Market Change Request

Number		Title	Priority
MCR	0088	Amendments to MPD 1 (Change of Supplier – NQH Metered) to satisfy new requirements for SEM Implementation	<i>HIGH</i>

Date	Version	Reason For Change
24/10/2006	1.0	Draft for IGG Review
15/11/2006	1.1	As detailed in “Responses to AIP MCR Comments”. Ref. 4, 5, 75

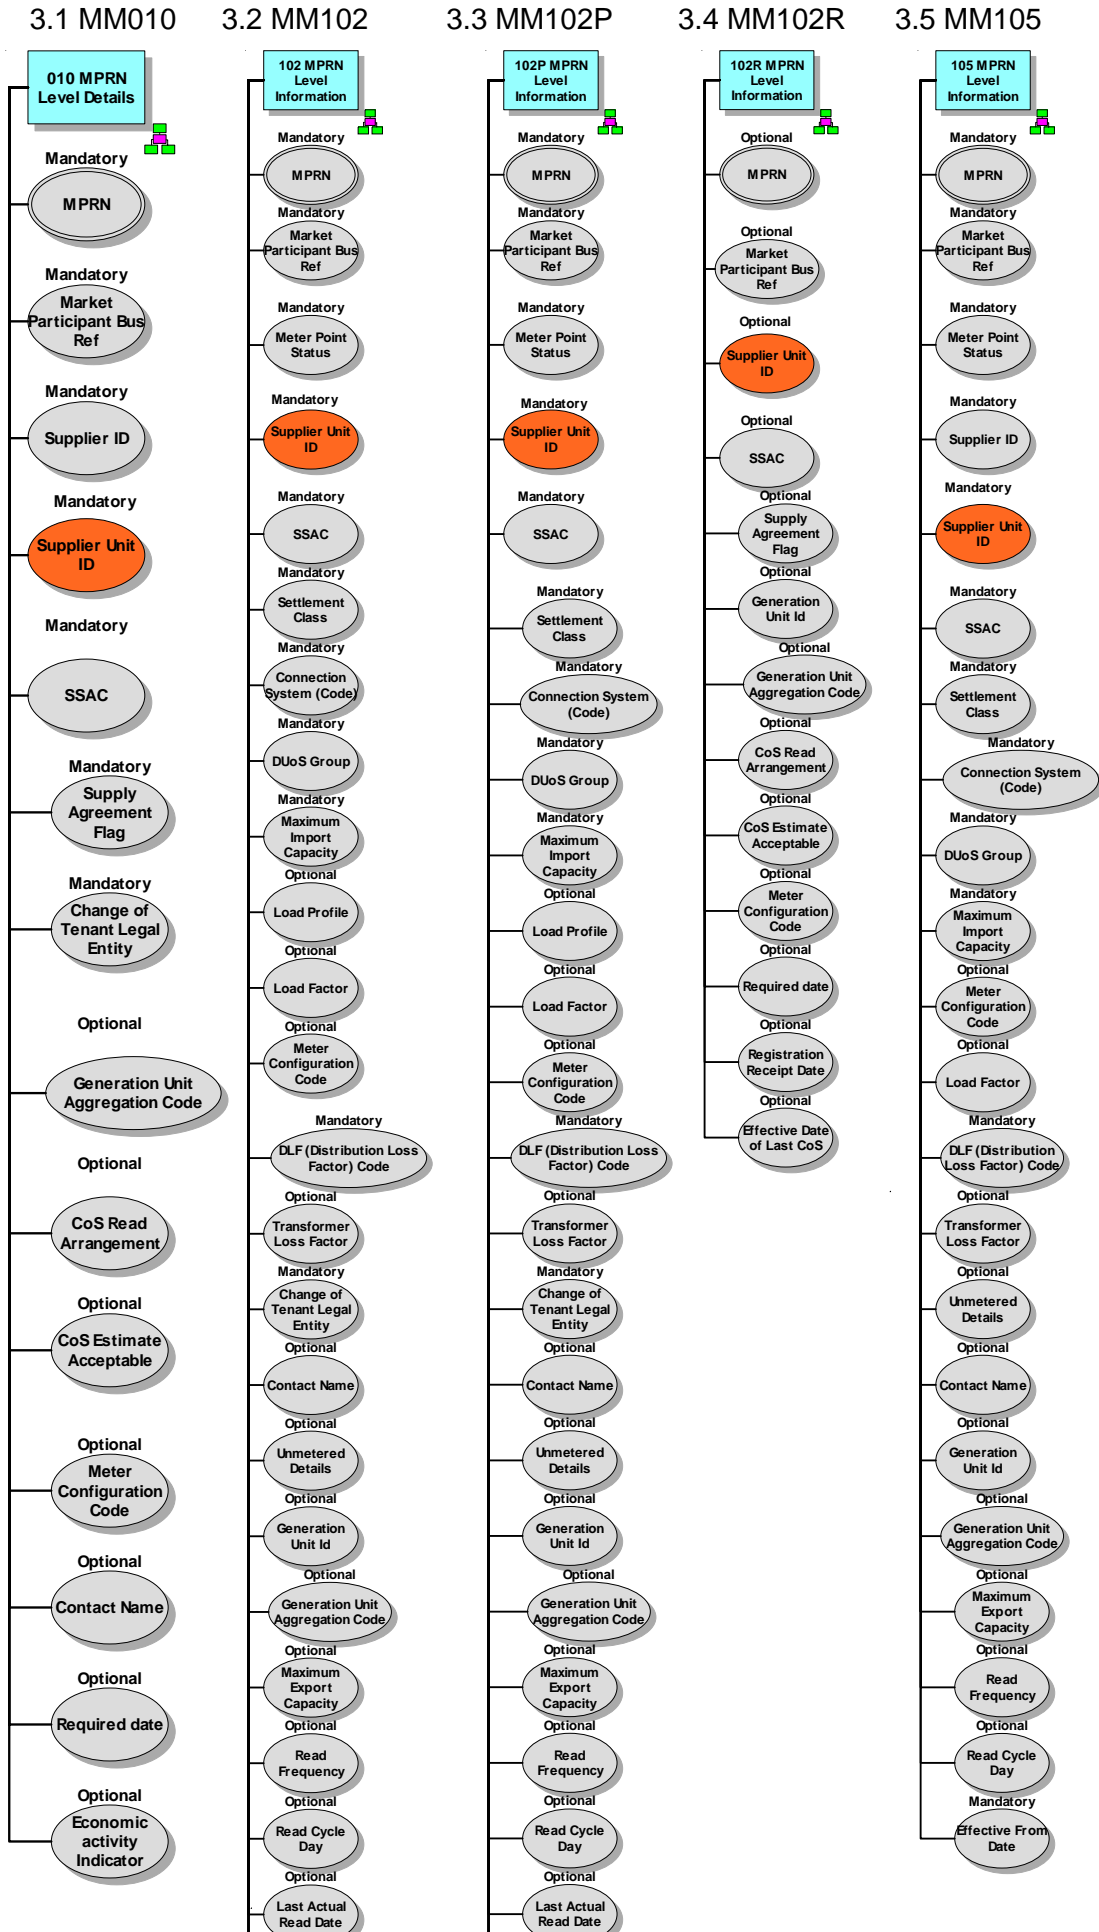
“Supplier Unit” will be added to the 010, 102, 102P, 102R and 105 Market Messages and Generation Unit ID removed from the 010, as follows:-
